REVISED RESPONSE TO REQUEST FOR ADDITIONAL INFORMATION

APR1400 Design Certification

Docket No. 52-046

RAI No.: 323-8281
SRP Section: 07.03 – Engineered Safety Features Systems
Application Section:
Date of RAI Issue: 11/30/2015

Figure 4.2-1 Overview Diagram of the CIM

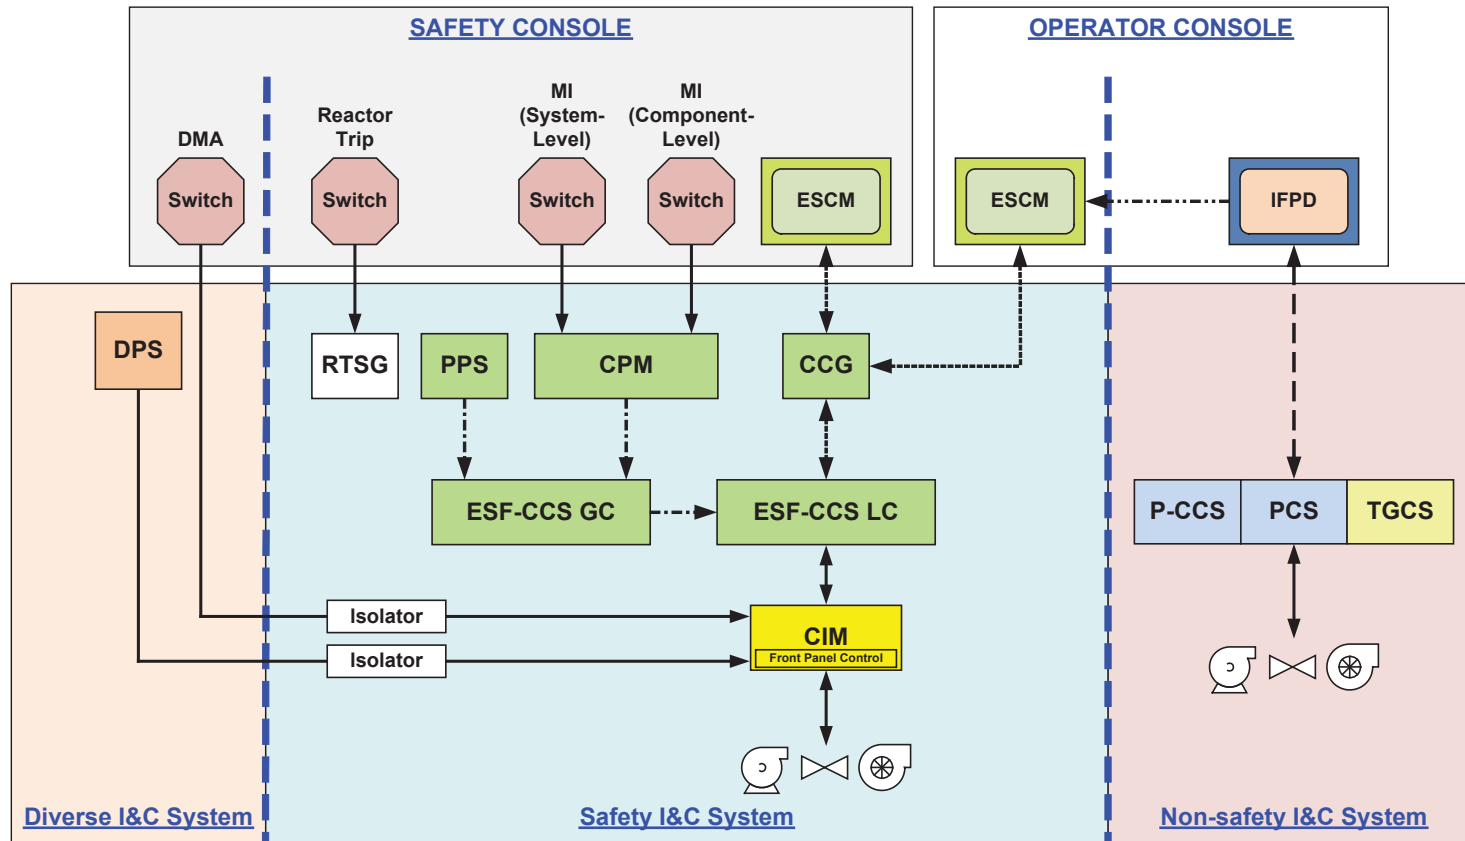
Provide design information on how the signals from the non-safety-related diagnostic section of the component interface module (CIM) will not interfere with the safety functions of the ESF-CCS loop controllers.

Figure 4.2-1, “ Overview Diagram of CIM,” of Technical Report APR1400-E-J-NR-14001-P, Rev.0, “Component Interface Module,” identifies that signals from the diagnostic section of the CIM are inputs to the safety-related ESF-CCS loop controller. These diagnostic functions are non-safety related. Describe the measures taken to prevent those non-safety diagnostic signals from interfering with the safety functions of the ESF-CCS loop controllers.

The diagnostic section of the component interface module (CIM) and the signals generated by that section are classified as safety grade, as stated in the third bullet of Section 4.2. That paragraph incorrectly states that the diagnosis section is software integrity level 3 (important to safety); but since the hardware of FPGA-based diagnosis section is designed as Class 1E, the application program of diagnostic function is qualified as software integrity level 3 grade (important to safety, ITS) of the software quality, and the engineering tool to configure the diagnostic logic in the FPGA is commercial grade software.

The diagnosis section generates signals that are transmitted to the Information Processing System (IPS) through the engineered safety features-component control system (ESF-CCS) loop controller (LC) and the maintenance and test panel (MTP) for the purpose of monitoring. These signals are used only for monitoring by the IPS; they do not perform any safety function within the ESF-CCS LC. Therefore, these signals completely bypass all component control logic functions within the ESF-CCS LC. This means there is no interface between these monitoring signals and any ESF-CCS LC logic functions

The signals that are used in the component control logic of the ESF-CCS LC (e.g., energized/de-energized, motor control center power fail, coil circuit open) are input to the ESF-CCS LC through the relays on the CIM module in Figure 4.2-1.

The third bullet of Section 4.2 will be revised as indicated in the attachment associated with this response.
